To: T10 Technical Committee

Re: SAS Bit Ordering Diagrams Change Proposal

Revision 1: Modified proposed diagrams as requested during SAS Protocol WG Conference Call on 10-22-02. Also modified STP diagrams to swap the byte order and remove the byte transpose blocks which were shown.

### **Proposed Changes to sas-r02a Specification:**

Figure 35 – SAS bit transmission logic

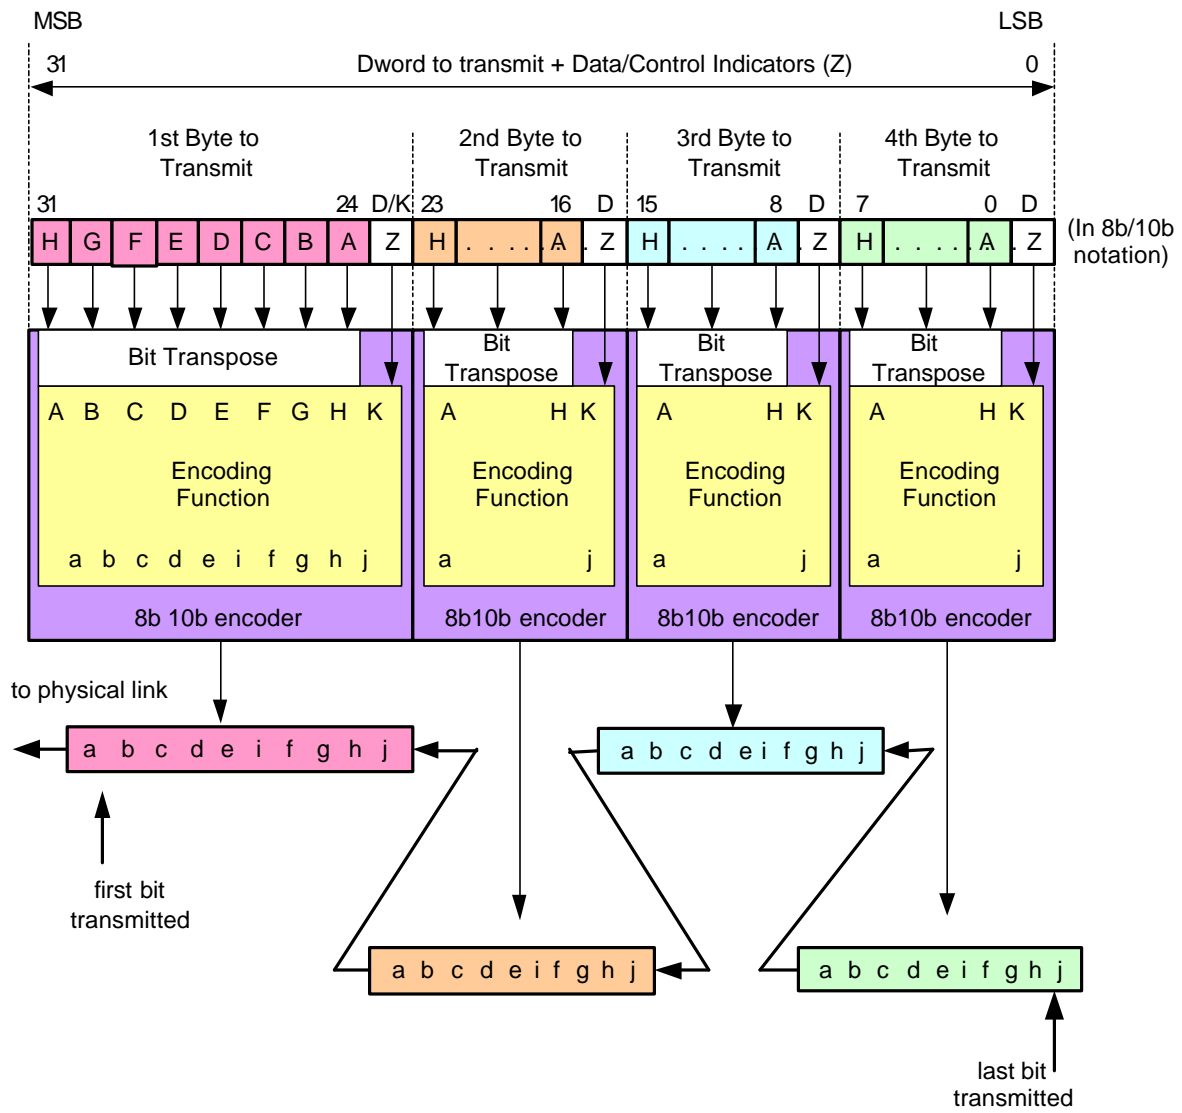
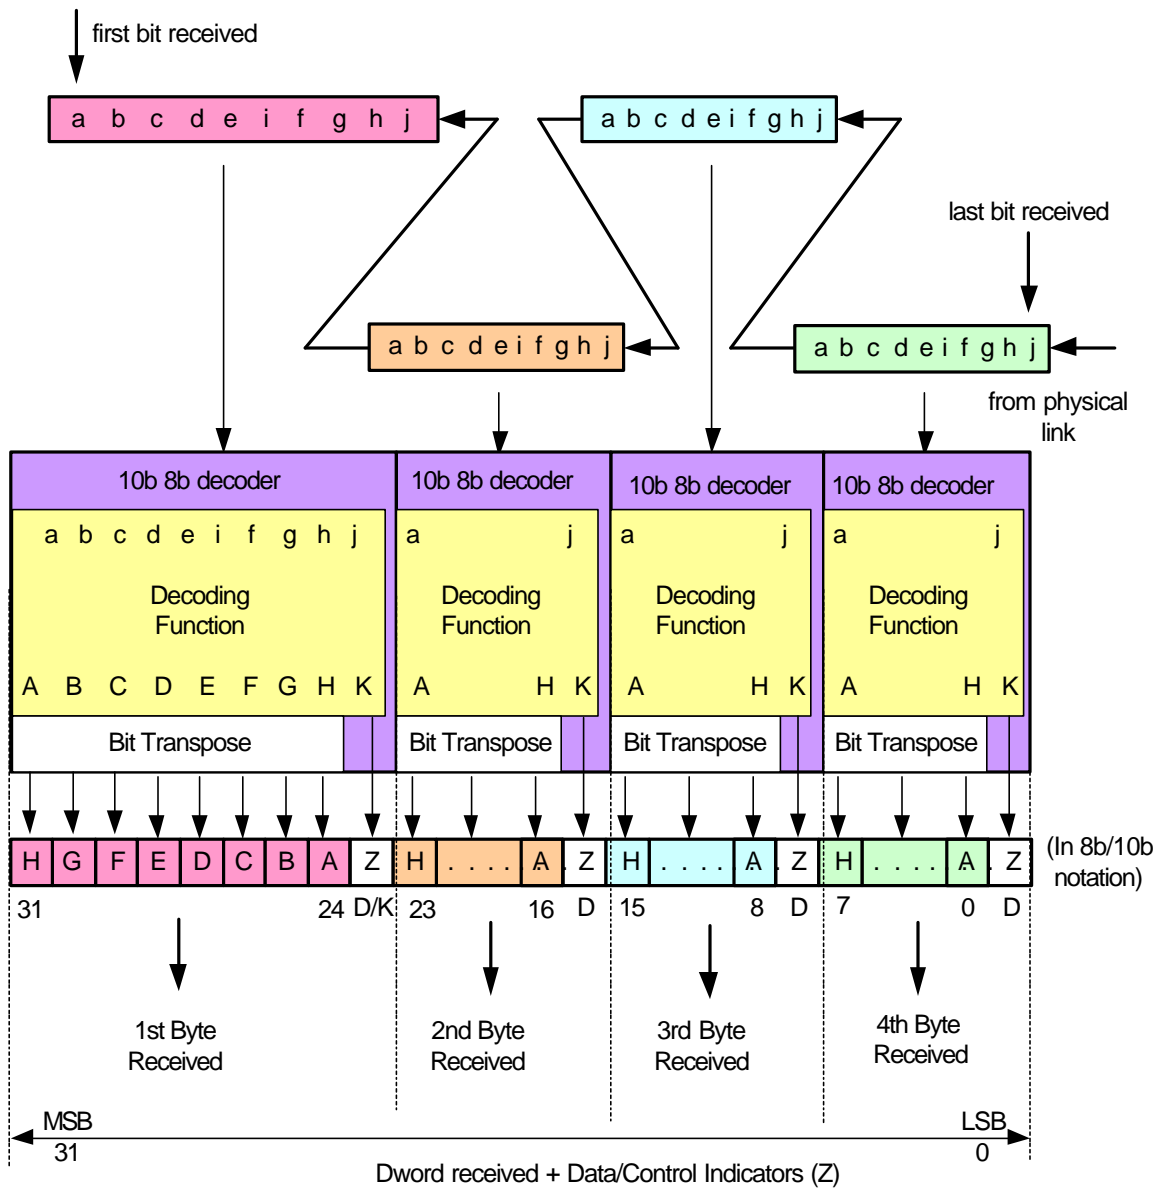
Figures 35 and 36 in sas-r02a show bit transposition logic required *prior* to 8b/10b encoding and *after* 10b/8b decoding. While bit transposition within a byte is actually required for 8b/10b encoding and decoding as defined by the original 8b/10b encoding patent, the bit transposition is done *inside of* the 8b/10b encoder and 10b/8b decoder, *not outside of* them, as depicted in the current figures. This document proposes a modification to Figures 35 and 36 in order to better correlate them to Tables 22 and 24, as well as to show that one does not have to perform a bit transposition on an 8-bit value prior to looking up the associated 10b encoding in Table 24.

- 1) Figures 35 and 36 show bit transposition being done within each byte of a dword outside of the 8b/10 encoding/decoding logic. Propose that these diagrams get replaced with the following diagrams:

**Figure 55 – SSP/SMP CRC generator/checker byte and bit order**

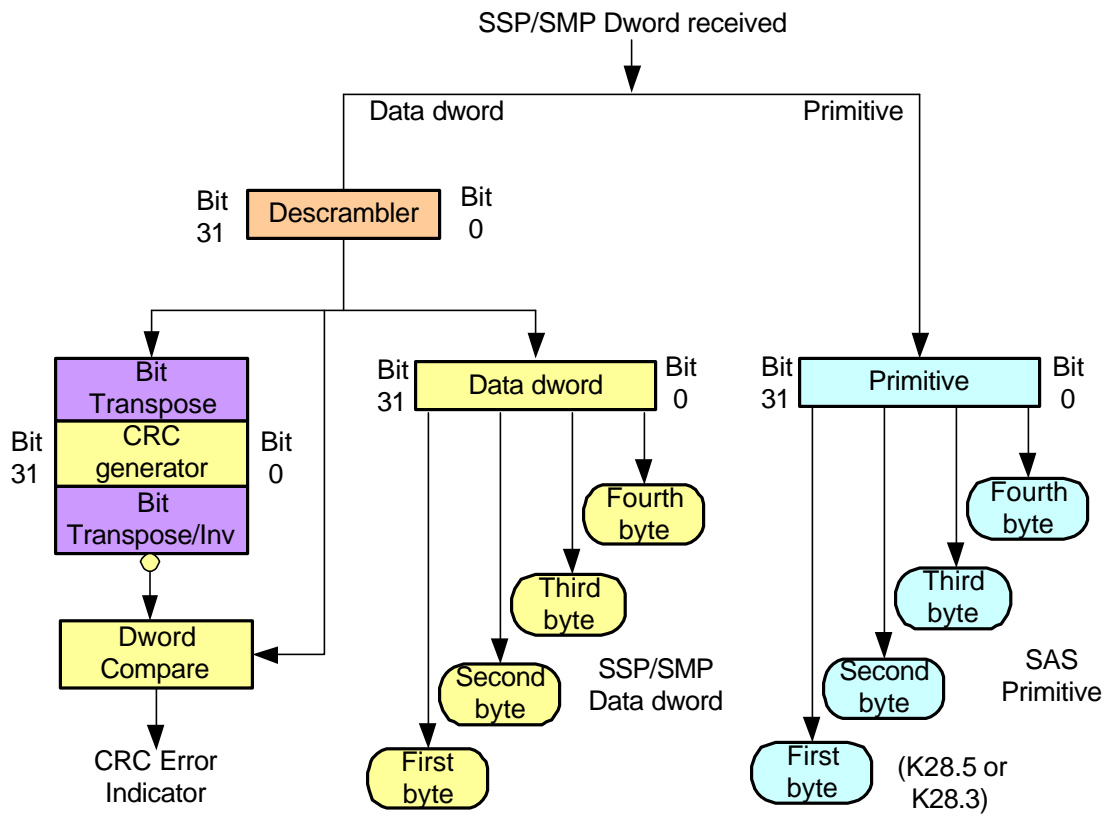
2) Figure 55 is missing bit inversion at the output of the CRC generator. Propose to replace with the following figure which shows the outputs being inverted, and shows the bit ordering within each byte:

**Figure 56 – SSP/SMP Transmit path byte and bit ordering**

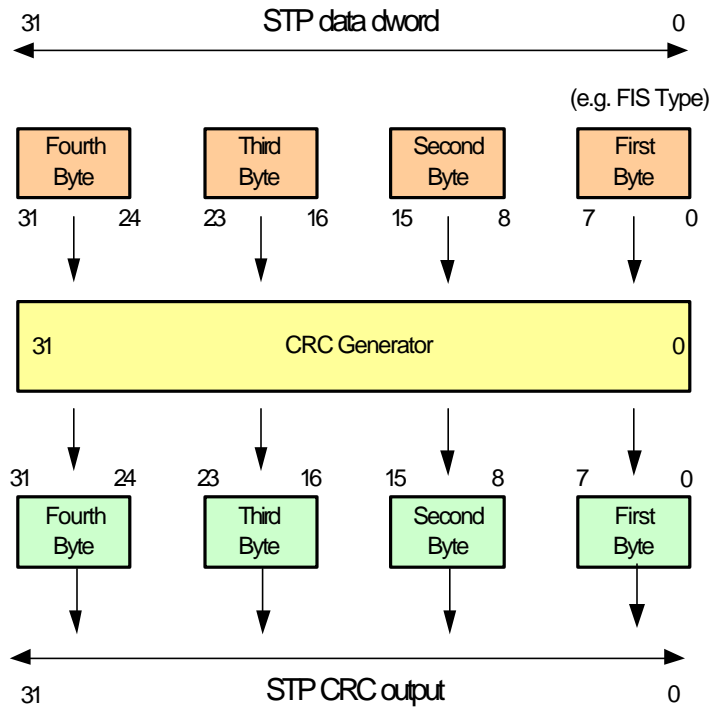
3) Figures 56 and 57 do not show the bit transposition and inversion logic associated with the SSP/SMP CRC generator/checker. Propose to replace with the following figures:

**Figure XX – STP Receive path byte and bit ordering**

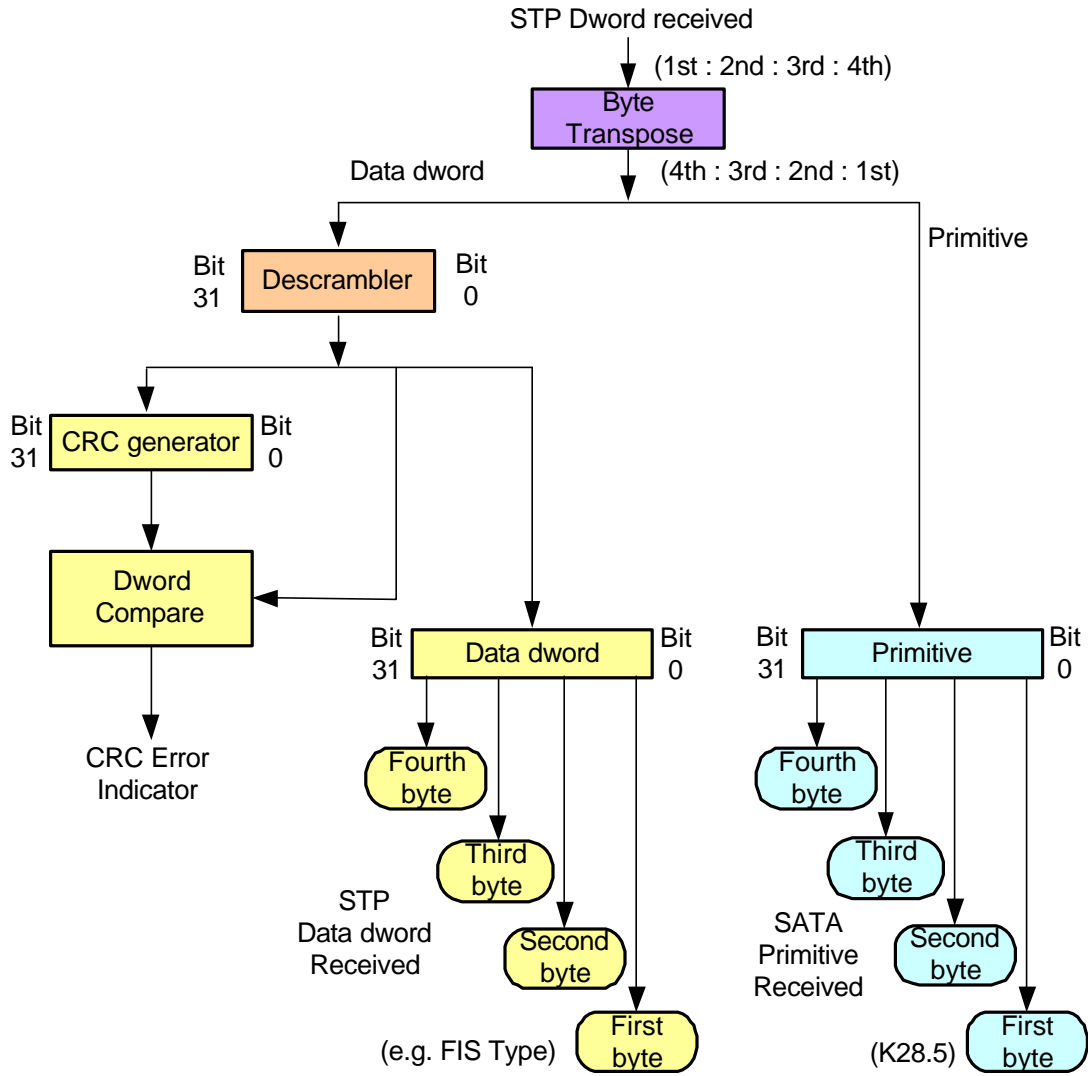
- 4) Propose that three diagrams be added *to the Appendix* to clarify the byte ordering for STP data paths and the difference between SSP, SMP and STP CRC requirements.
